Melrose Heights/Oak Lawn Architectural Conservation District

DESIGN/DEVELOPMENT REVIEW COMMISSION
DESIGN REVIEW DISTRICT
HISTORIC AGENDA
EVALUATION SHEET
Case # 7

ADDRESS: S/S Longleaf Rd., 3000 block

NATURE OF REQUEST: Request Certificate of Design Approval for new construction of single-family house

Façade submitted by applicant (flipped by staff)

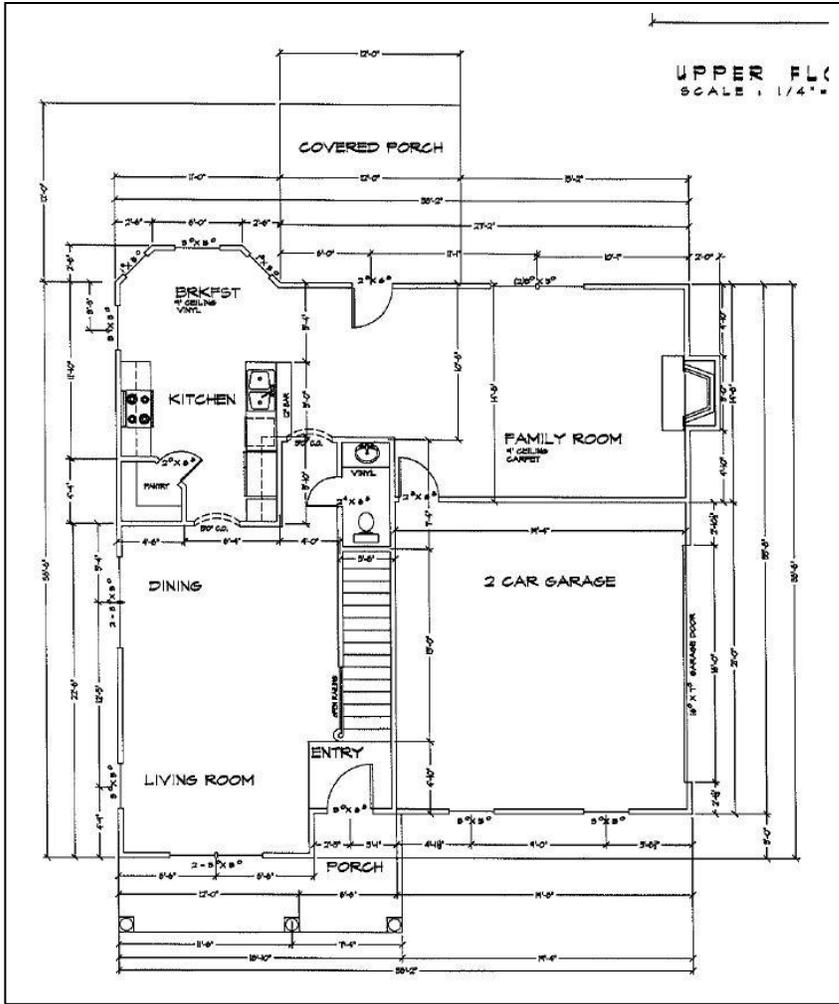
The massing of the proposed building is not compatible with historic two-story buildings in the district. It appears to be divided into two vertical halves that have little relationship to each other, as each of their massing is different from the other. This disunity in the façade is unlike historic single-family homes in the district. There are other massing features that are not compatible with historic buildings. The porch gable covers almost half of the front elevation but the porch wall recesses on both floors about 2/3rds of the way across the porch. This makes the gable of the porch and the porch itself somewhat disjointed, which is not compatible with historic buildings. A nearby home at 1401 Shirley has a gable that is the width of the projecting bay. Another component of the massing is the relationship of solid components like walls to open spaces such as windows and doors. The doubled doors and single door on the second floor porch wall creates a much larger opening than is visually compatible with historic front facades in the upper stories and the presence of four full-size doors in the façade is not visually compatible with historic buildings. Side elevations may feature more doors leading to porches, but historic facades do not typically have this feature.

The house has a somewhat strong sense of entry due to the door's location and the surrounding porch.

The rhythm of openings on the façade is somewhat consistent with rhythm of openings found on historic buildings, with at least one opening in each of the defined bays. The right elevation also creates a rhythm of openings that is compatible with historic buildings. The left elevation does not achieve the same rhythm. It has two single windows on the second story, spaced well apart, but the first story has only one large opening. The large double-car garage door opening is unlike any feature found in the rhythm of openings in historic buildings in the district. Openings of that size disrupt the established patterns found in the area; therefore the proposed rhythm of openings does not meet the guideline.

Porch: The porch presented is two stories and is located on the right half of the façade. Porches are common in the district, but there do not appear to be any examples of two-story porches in the district, therefore the porch design does not meet this guideline.

Door: The proposed main entry door is fiberglass with an oval glass with etching. This type of door is not typical for the historic district. While the material will be indistinct once painted, the shape and character of the glass is not found on historic buildings nearby. The upper story features three full glass doors with muntins. As second-story porches are not typical, this arrangement of multiple doors on a second-story façade is not visually compatible with the historic district. The proposed doors do not meet the guidelines.

Left elevation, provided by applicant, flipped by staff

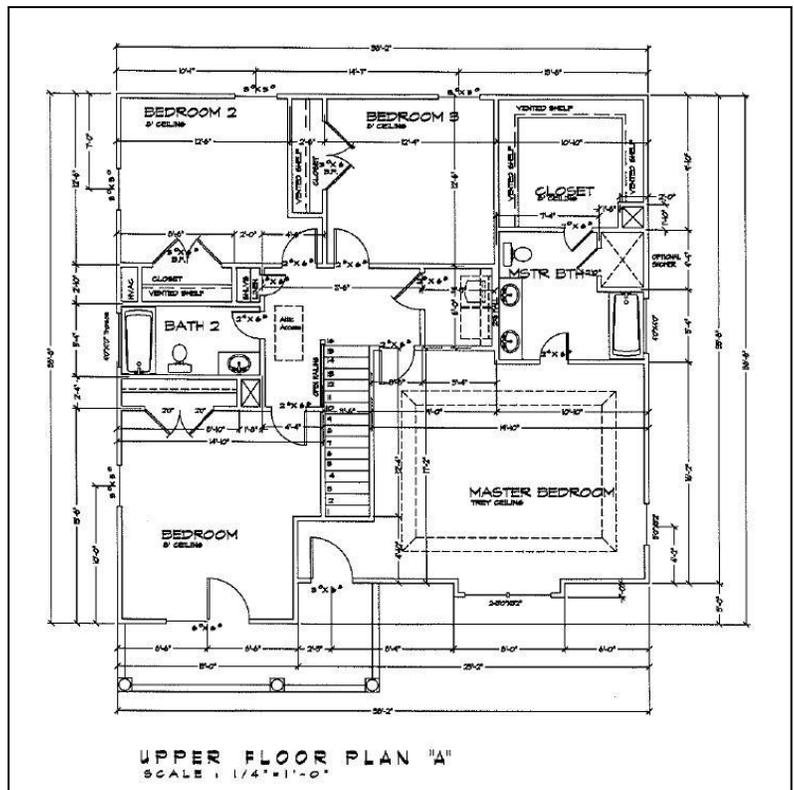
On the left elevation the first floor has a large, double-car garage door. This oversized opening is not found on historic buildings. Although the applicant moved the garage door from the façade to a side elevation, the side elevations of historic buildings in the district still do not feature such oversized openings. The large amount of solid space on this elevation is also not typical of the area. The garage door opening is also inconsistent with the massing of openings due to its requirement to disrupt the foundation wall. Openings in historic buildings are located within the wall plane, not the foundation wall. Due to the slope of the lots, the garage door will interrupt a somewhat tall foundation wall, and the top of the garage opening will be lower than typical window heights along the side elevation.

This will disrupt the massing of the two stories on this elevation that should appear somewhat consistent in height in order to be visually compatible with historic buildings.

The left elevation has a lot of solid space in relation to voids like window openings and does not appear consistent with historic patterns. The right elevation has a more consistent pattern, although the ribbon or transom window is too small to replicate the typical massing of a normal sized window.

Windows: Most of the windows will be aluminum-clad wood, double hung in appearance with the typical 3’x5’ size. There appears to be a square, glass-block window in the center of the second story on the left side. Glass block is not a feature that is compatible with historic buildings as it was not used historically on these buildings. There is a ribbon or transom window in the center of the upper story on the right side. This too is a feature not typically found on historic buildings. The one-foot deep “bump out” window bay on the façade’s second floor also introduces a feature that is not visually compatible with historic buildings in the area. The bump out itself is not typical, but it also includes very thin windows on the sides that are not visually compatible with the district. Therefore, there are several windows proposed that do not meet the guidelines.

Other Details: The fireplace “bump out” bay on the left side is not visually compatible with historic buildings. Chimneys are typical, but these short, small projections are not typical and the D/DRC has repeatedly denied this feature on several other projects.

PROPOSED NEW RESIDENCE SITE PLAN FOR

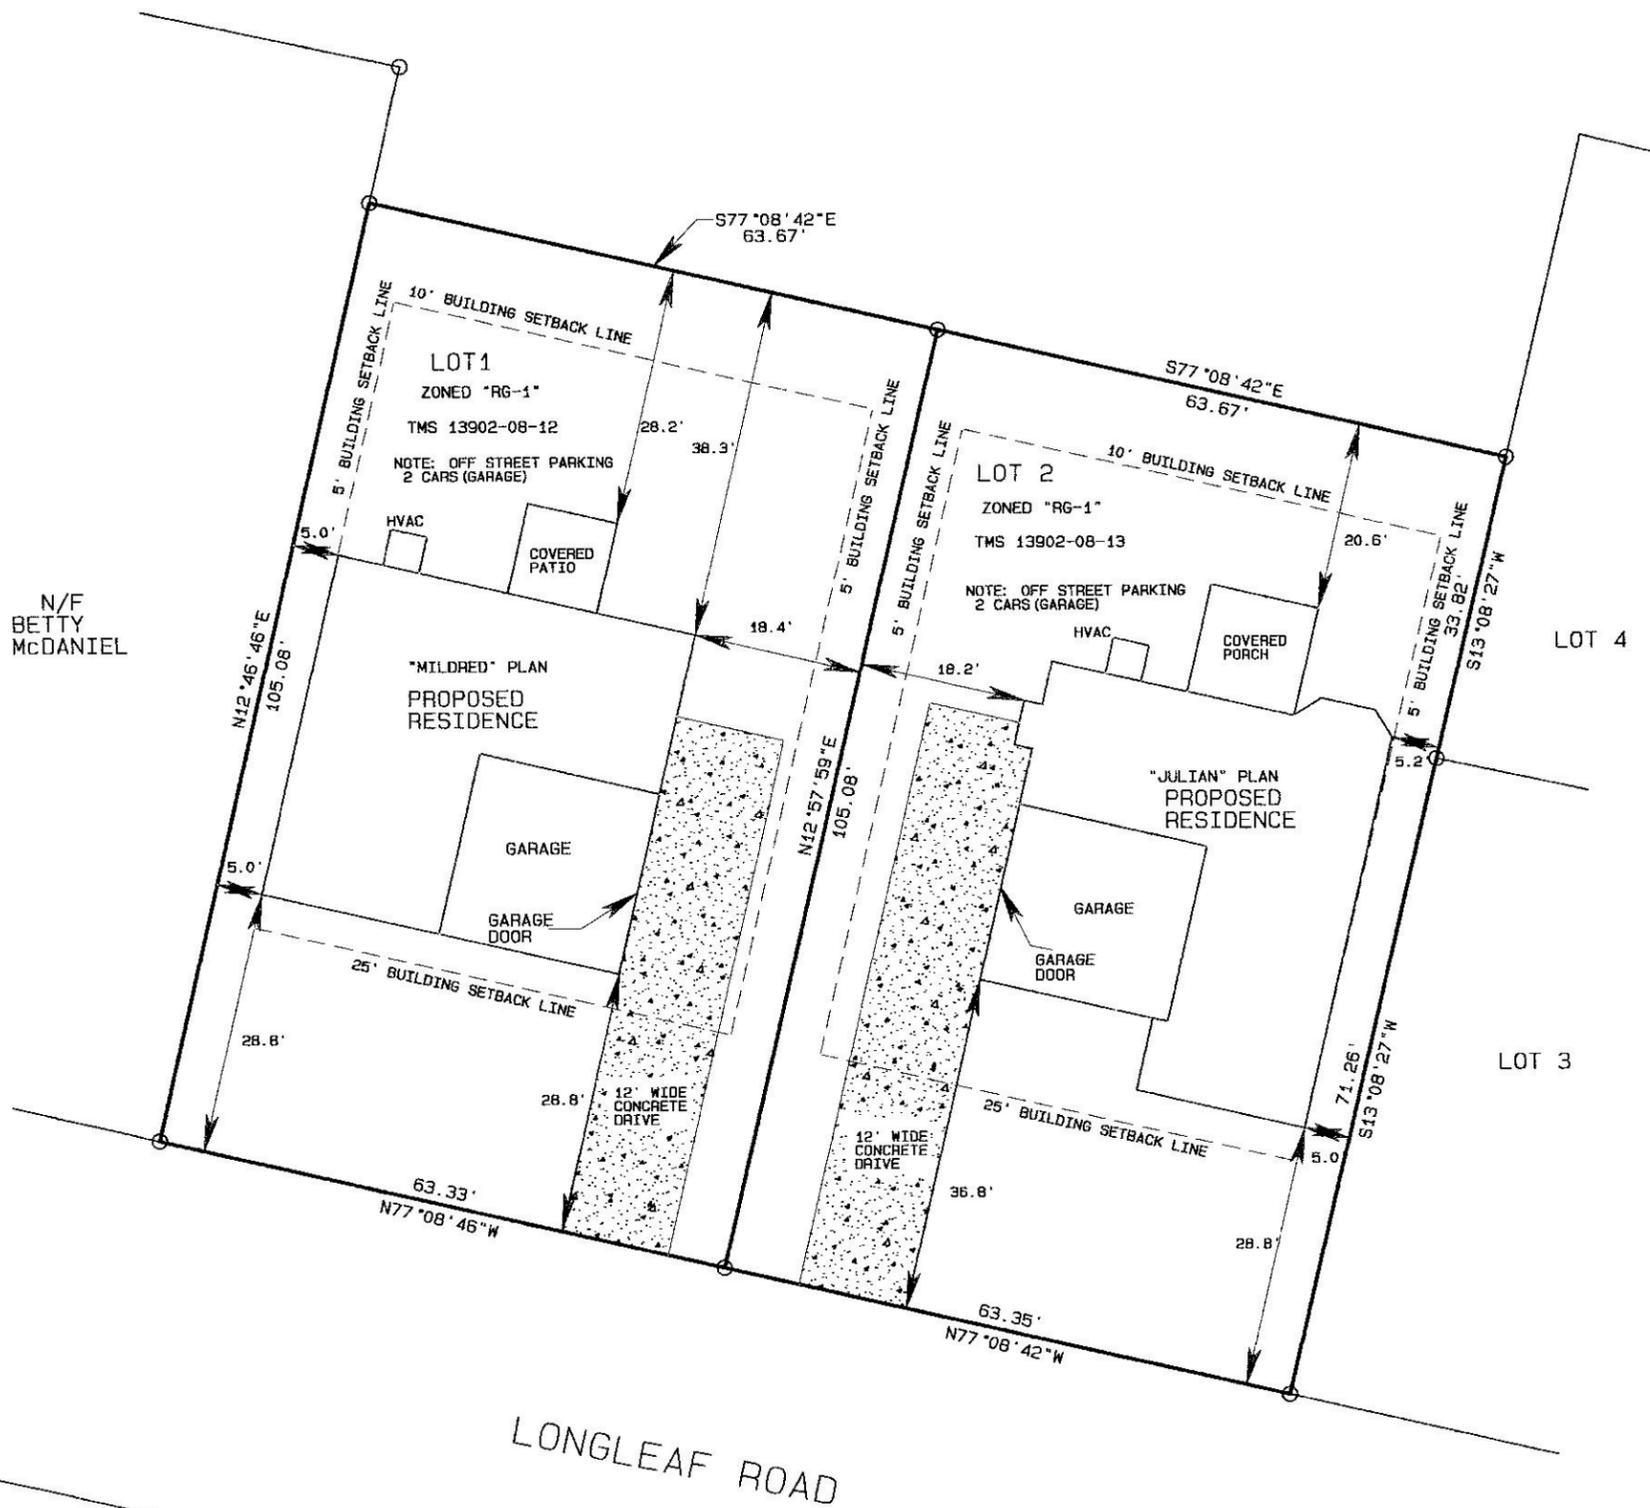
project lots slope from south to north, or down towards the street, and west to east, creating some challenging terrain. From the highest point (southwest corner) to the northeast corner, the lowest point along the street, there is approximately a 12-foot drop. The applicant plans to grade the lot to achieve as flat an area as possible for the house, but has not provided a grading plan to show how this will be accomplished. The lot is approximately 63-feet wide and 105 feet deep.

The height of the building is two stories, which is found in the district, however staff has not been provided measurements on the total height of the building. The site plan provided by the applicant does not indicate where the grading will occur and how it will affect the perceived height of the house, whether it will diminish or enhance it, so it is somewhat difficult to discern the actual height. The plans do not give an indication of the building's height to the roof peak; there are some exterior measurements suggesting each floor has an 8' height, but there is no measurement provided that includes the area between the floors, the foundation height, or the roof height.
